## PRELIMINARY STAFF REPORT

Design Review: 148-14

**Applicant:** Campo Architects (for D-Barlo, LLC)

the First Municipal District, bounded by St. Charles Avenue, Girod, Church and Julia Streets. The municipal address is 744 St. Charles Avenue. The site is located within

**EXTERIOR ELEVATIONS**

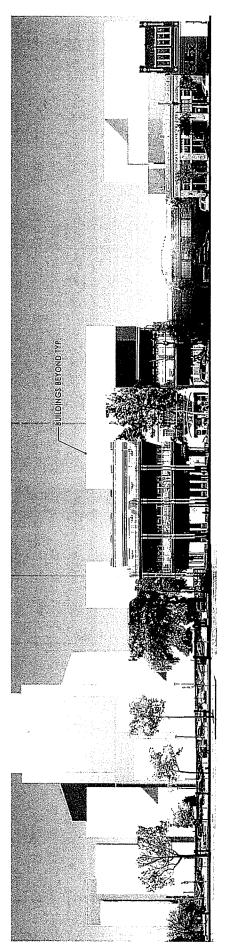
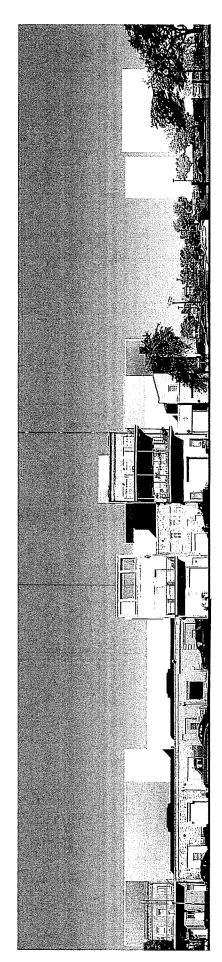
- o The scale of the building is much larger than the majority of the historic context.
- O The horizontal banding is atypical for a building of this size and makes the floor-to floor heights of the upper floors appear low.

- O The tower seems to be neither part of nor separate from the historic facade at the street level.
- o The tower lacks a coherent design.
- O The space between the top of the windows and the top of the parapet is very small and does not successfully cap to top of the building.

- O The design of the street facing elevations of the tower are not successful, they are neither asymmetrical enough to be interesting nor symmetrical enough to be balanced.

- O The quantity, size, and prominence of the balconies are atypical of the historic urban downtown context.
- O The corner windows, horizontal railings, and projecting base are typical to art deco style buildings, however, this style is not prevalent in this area, and these elements are not composed in a manner that evokes any style.

- o The large expanses of blank wall on the sides of the building are not appropriate.
- O The quantity, size, and spacing of the windows on the Church Street elevation is overly dense and busy. The contrast between this and the large blank wall adjacent both reinforces and highlights the negative aspects of both conditions.

- The inversion of the recessed/projecting elements that occurs between the first and upper floors of the Church St. elevation is awkward.

Based on the comments above, the HDLC is not supportive of the project design.
